## National Highways Authority of India

**POLICY MATTERS-Technical (189/2015)**  
(Decision taken in file No. NHAI/CMC/Misc./RBS)/2015)

**Sub: Providing Road Boundary Stones reg.**

Dimensions for Inscription of  
RBS, NHAI & No. on RBS

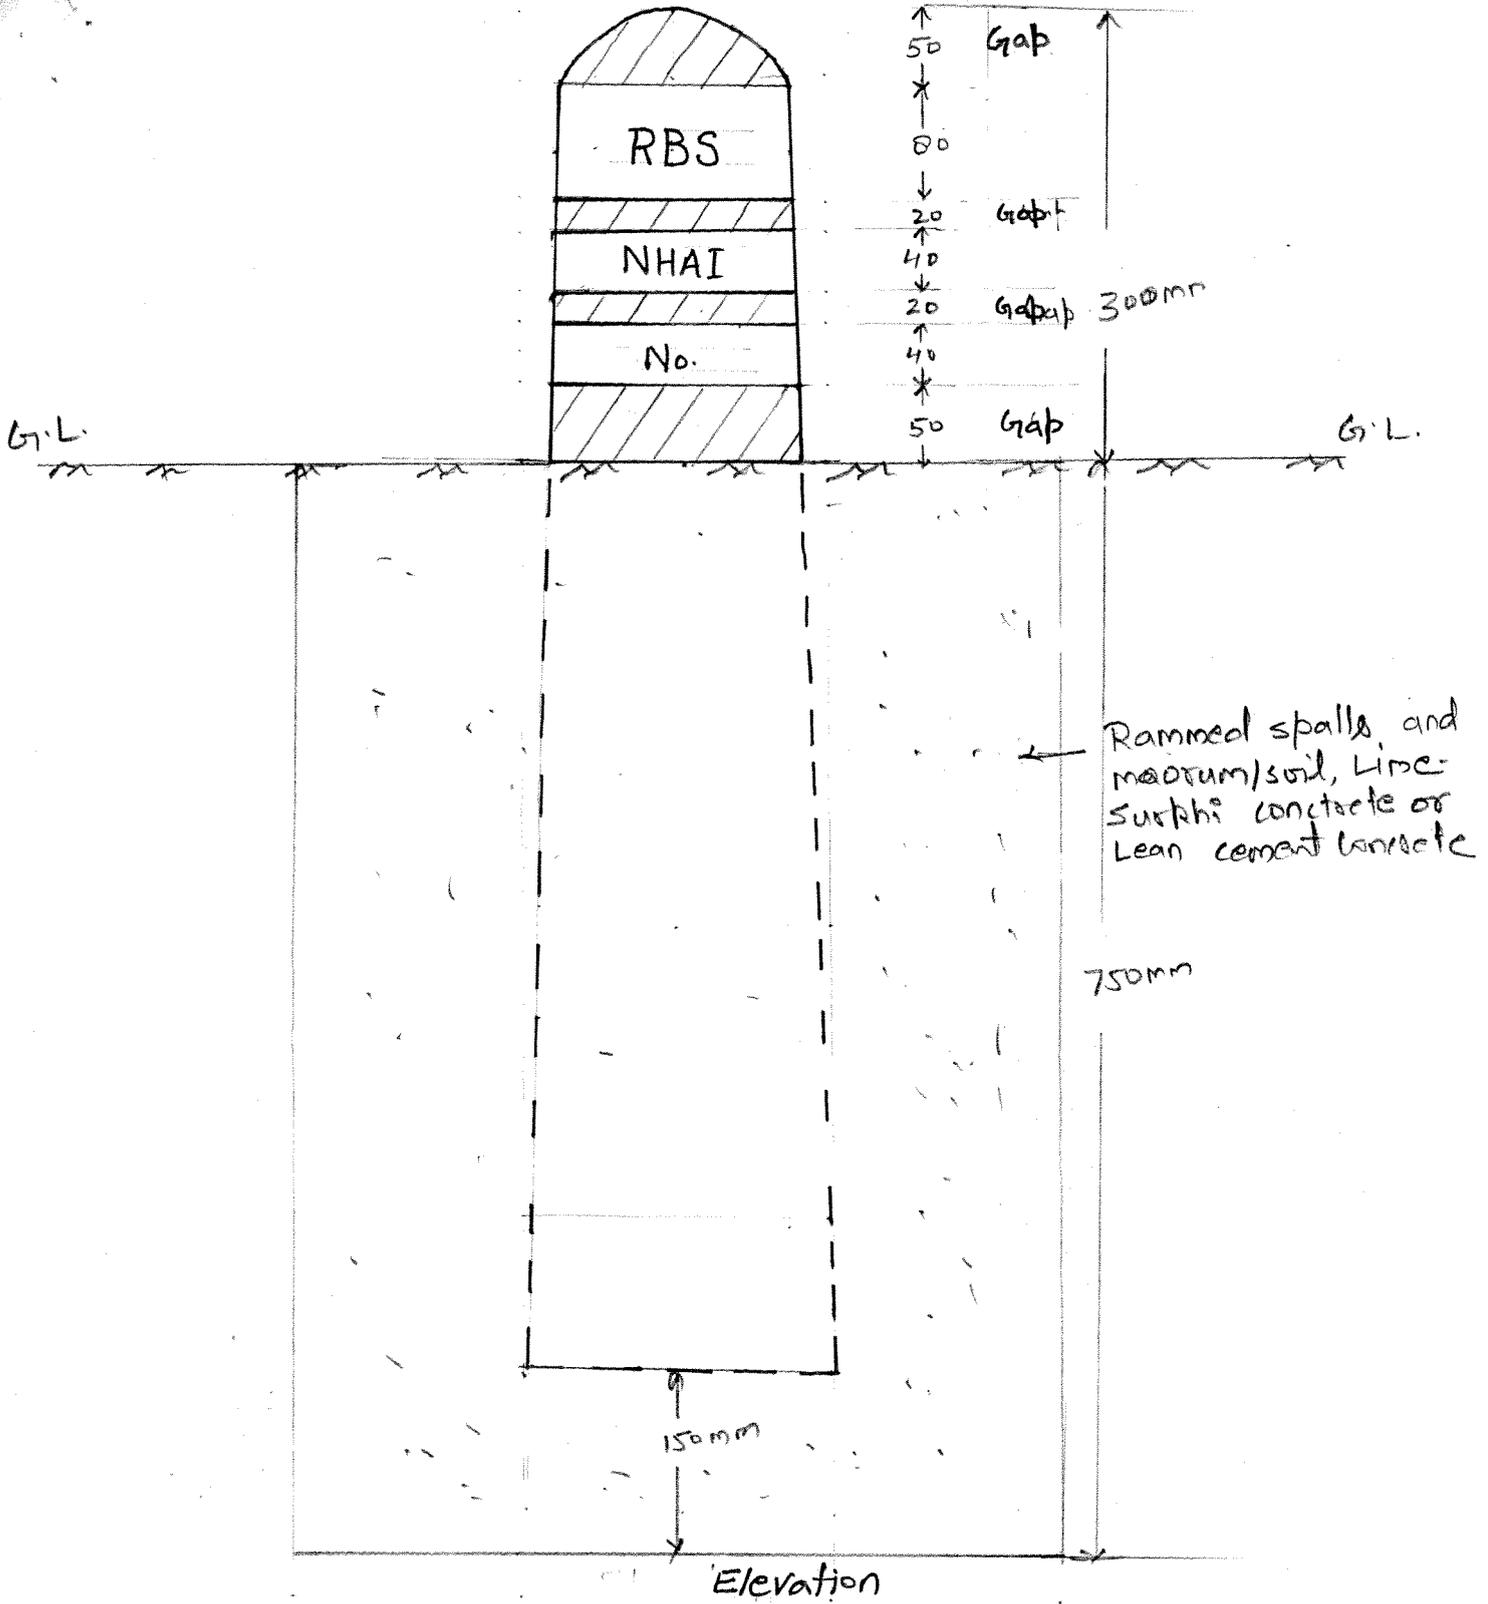
- (iii) RBS shall be numbered from 1 to 20 in each km. The proper numbering of Road Boundary Stone is also required for which specifications are enclosed as Annexure-I.
- (iv) The power to approve such Change of Scope/Variation has been delegated to respective Regional Officers. Regional Officers are advised to observe due diligence and NHAI extant guidelines to arrive at the cost of such change of Scope /Variation.
5. This issues with the approval of Competent Authority.
